RESOLUTION TO AUTHORIZE THE EXECUTION OF CHANGE ORDER 1 TO CONTRACT NUMBER 38, MONROE STREET PUMPING STATION AND FORCE MAIN AND MORRIS AVENUE GRAVITY SEWER

1. ISSUING OFFICE Rockaway Valley Regional Sewerage Authority	2. PROJECT NO. S340821-06	3. CONTRACT NO. 38	4. MODIFICATION NO. Number 1
5. TO (CONTRACTOR) Tomar Construction Services, Inc. 18 Connerty Court, Suite B East Brunswick, NJ 08816		6. PROJECT LOCATION AND DESCRIPTION RVRSA Contract 38: Monroe St. Pumping Station and Force Main & Morris Ave. Gravity Sewer Boonton, NJ

**RE: MONROE STREET PUMPING STATION & FORCE MAIN AND
MORRIS AVENUE GRAVITY SEWER
RVRSA CONTRACT NO. 38; NJEIT LOAN PROJECT S340821-06
CHANGE ORDER RECOMMENDATION –
CO #1 – FORCE MAIN & RELATED PIPING CONSTRUCTABILITY ADJUSTMENTS**

Series 40W Pressure Sensor

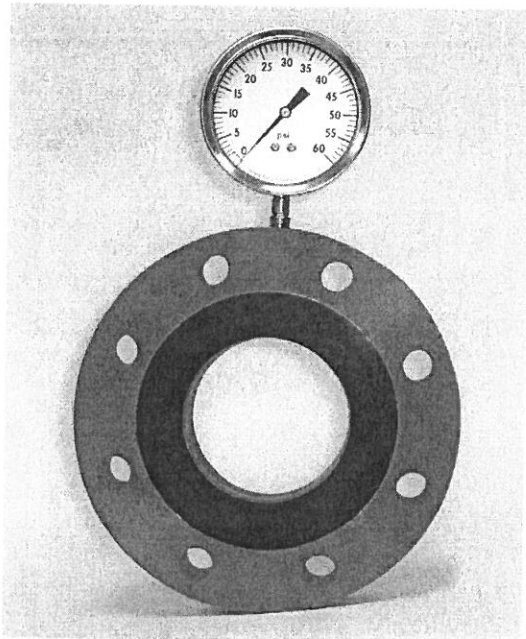
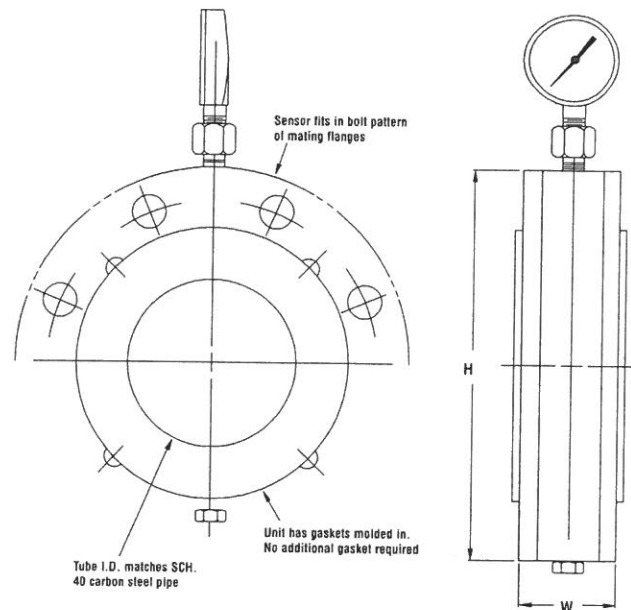
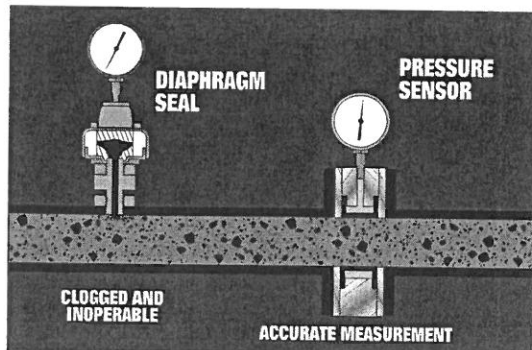
Per your request please find attached quote for replacing the pressure gauge connection with diaphragm seal & snubber per detail on drawing PR -6 with annular style Red Valve pressure gauges.

Thanks Robin... need to temper that with a credit for the "regular" pressure gauge riser, which includes the riser, the gauges, the diaphragm seals, and the flushing line – all per the detail on PR-6.

It is recommended that the risers and diaphragm seals illustrated on the Documents be replaced with in-line annular seals. This style of seal not only affords more accurate pressure sensing, but it is not prone to clogging in any way. Thus, proceeding in this fashion will not just ensure more accurate gauging, but will eliminate the need for regular, manual flushing of the
